SUBJECT: DEMONSTRATION / DELIVERY HOLD - Safety Recall 14S03 - Supplement #1
Certain 2013-2014 Model Year Escape Vehicles
Exterior Door Handle Inspection and Adjustment

REF: DEMONSTRATION / DELIVERY HOLD - Safety Recall 14S03
Dated May 7, 2014

New! REASON FOR THIS SUPPLEMENT

FIGURE 3

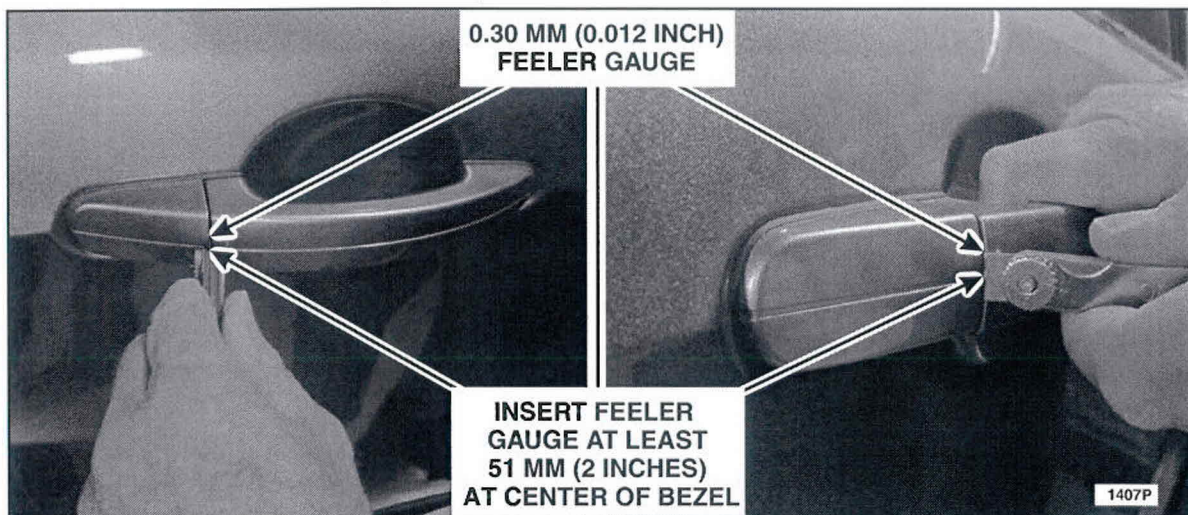
4. Insert the 0.30 mm (0.012 in) feeler gauge between the door handle and the bezel as shown. See Figure 3.

- The feeler gauge should be inserted:
 - at the center of the bezel.
 - at least 51 mm (2 inches).

FIGURE 4

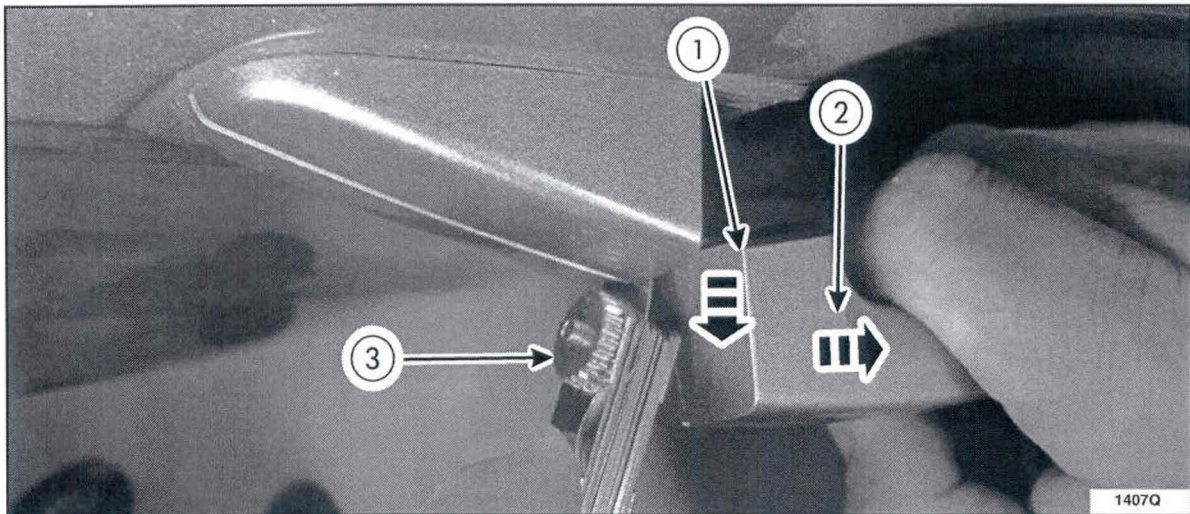
5. While holding the feeler gauge in position, complete the following steps in the order indicated.
See Figure 4.

- (1) Pull the door handle all the way open.
- (2) While holding the door handle in the open position, force the door handle forward (toward the front of the vehicle) as far as possible to increase the gap.
- (3) Gently pull the feeler gauge.

- **PASS INSPECTION:** If no resistance is felt when removing the feeler gauge, no further action is required for this door handle. Repeat Step 2 through Step 5 for remaining door handles.
- **DID NOT PASS INSPECTION:** If any resistance is felt when removing the feeler gauge, the door handle reinforcement needs adjustment. Repeat Step 2 through Step 5 for remaining door handles.

FIGURE 9

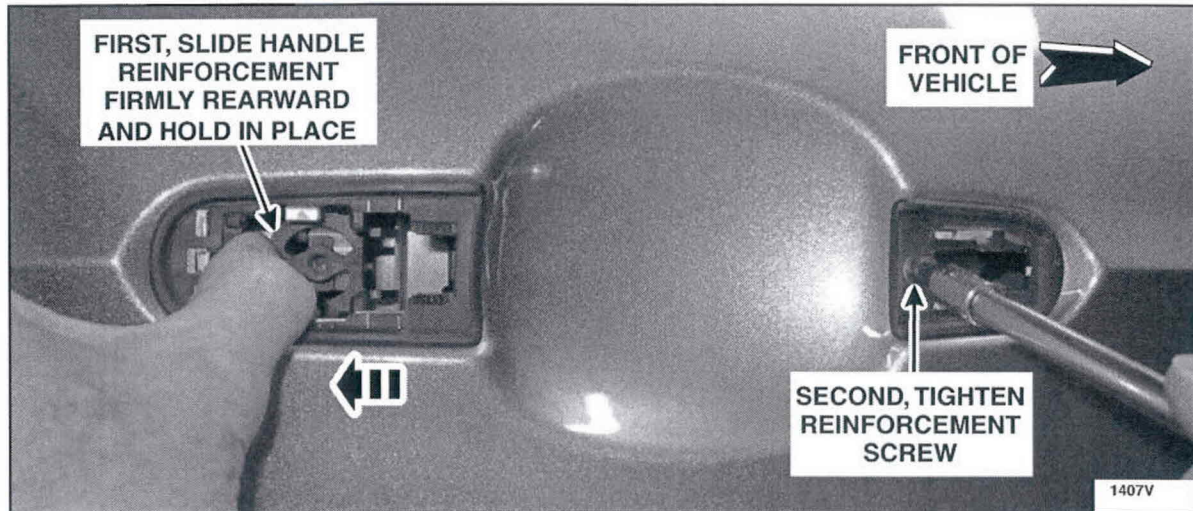
5. Slide the door handle reinforcement rearward as far as possible. Apply force to hold in place while tightening the door handle reinforcement screw to 1.9 Nm (17 lb-in). See Figure 9.

FIGURE 10

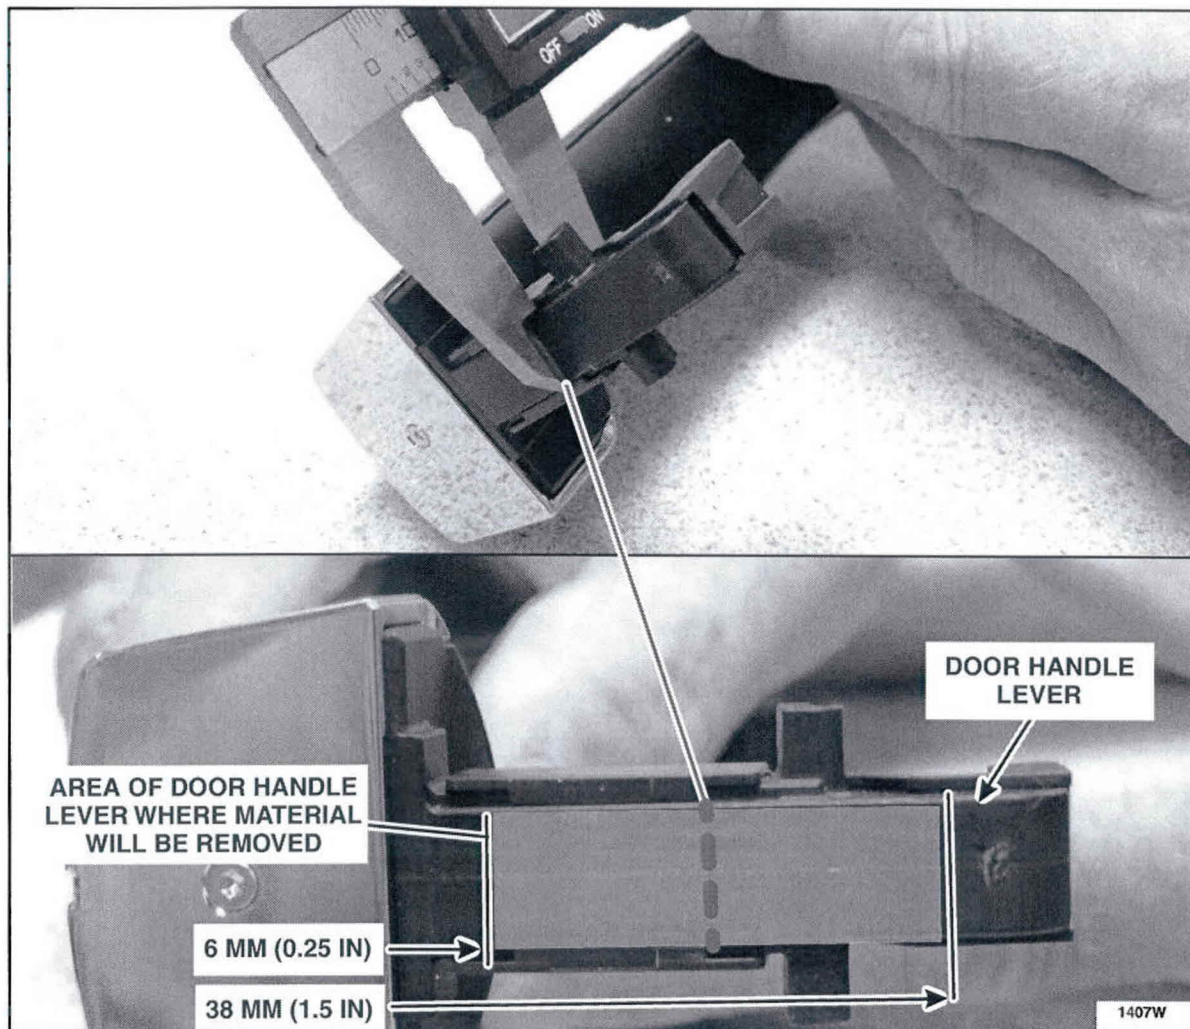
1. Remove the body plug from the door. See Figure 5.
2. Using a T-20 Torx® driver, loosen the bezel retainer screw until the exterior door handle bezel can be removed. See Figure 6.
3. Remove the bezel and the door handle (**do not** remove gaskets). See Figure 7.
4. Using a digital caliper, measure and record the door handle lever thickness at the center of the area where material will be removed. See Figure 10.

FIGURE 12

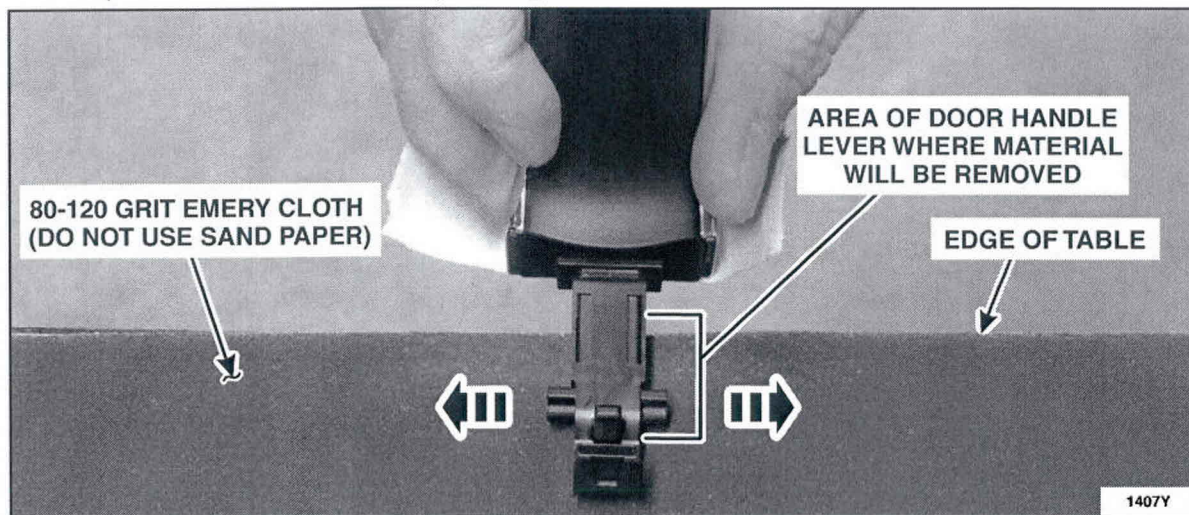
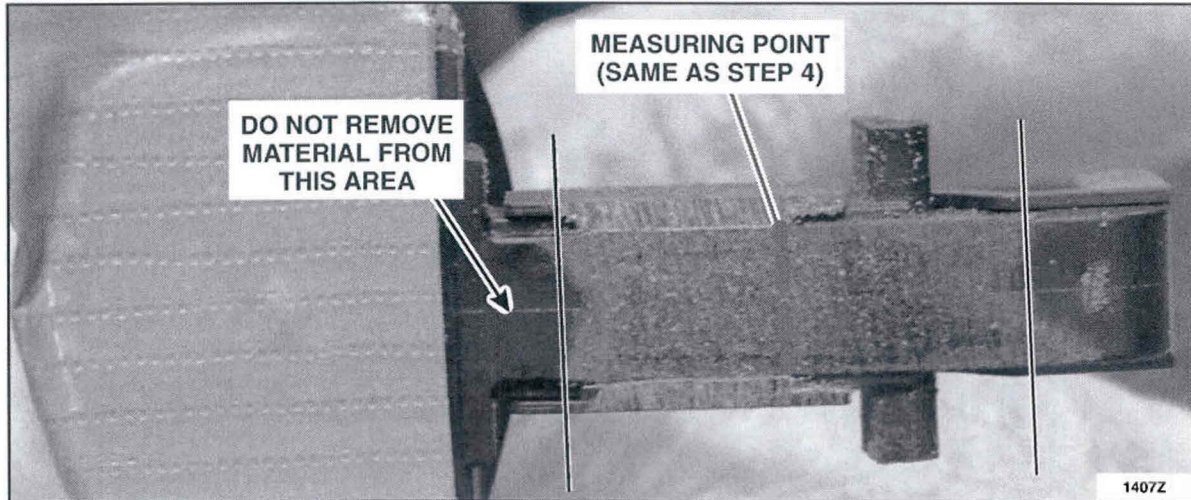
6. Place a sheet of 80-120 grit emery cloth on the edge of a table and place the door handle lever on top of it. (DO NOT USE SAND PAPER) See Figure 12.

7. Rub the handle back and forth across the emery cloth until 0.508 mm (0.020 in) of material is removed from the door handle. See Figures 12 and 13.
